Groundwater Transfer Review Summary Form

Transfer/PA # T- <u>14598</u>

GW Reviewer <u>James Hootsmans</u> Date Review Completed: <u>3/21/2025</u>

T14598 Woodburn Organic Farms LLC

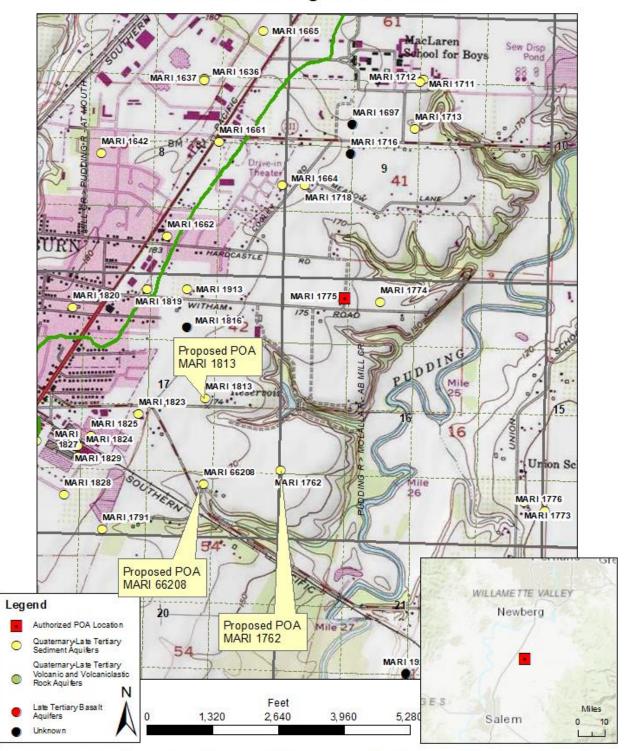
☐ Yes ⊠ No Comments: <u>All POAs indicated on this application are similar distances</u> to other groundwater POAs. The three additional POAs are already authorized POAs on other certificates. Water level data is sporadic, however water level data for Sections 8, 9, 16 and 17 seem stable. Based on nearby surface water bodies and the water level data, the groundwater resource seems stable.

Proposed APOAs MARI 1762 and 1813 are authorized POA on Certificates 97284 and 97285. On Certificate 97284, the maximum rate that either MARI 1762 or MARI 1813 can pump is 0.76 cfs or 0.38 cfs if they split evenly. On Certificate 97285, the maximum rate that either MARI 1762 or MARI 1813 can pump is 1.67 cfs or 0.835 cfs if they split evenly. Proposed APOA MARI 66208 is an authorized POA on Permit G 17558, with a maximum allowed rate of 0.35 cfs. Therefore, to protect the resource, water level measurements should be included on the new certificate for all POAs to help eliminate the potential of stacked use in the given wells.

\Box Yes \boxtimes No Comments: <u>All POAs indicated on this application are similar distances</u> to nearby surface water bodies. All the nearby surface water bodies are part of the Pudding <u>R > Molalla R – AB Mill CR Water Availability Basin, therefore any acute changes in</u> depletion of specific surface water bodies will not affect the overall water availability.

8. What conditions or other changes in the application are necessary to address any potential issues identified above: The additional POAs are authorized wells on other Certificates. To protect the resource, the new certificate should include water level measurement requirements as part of approving this transfer.
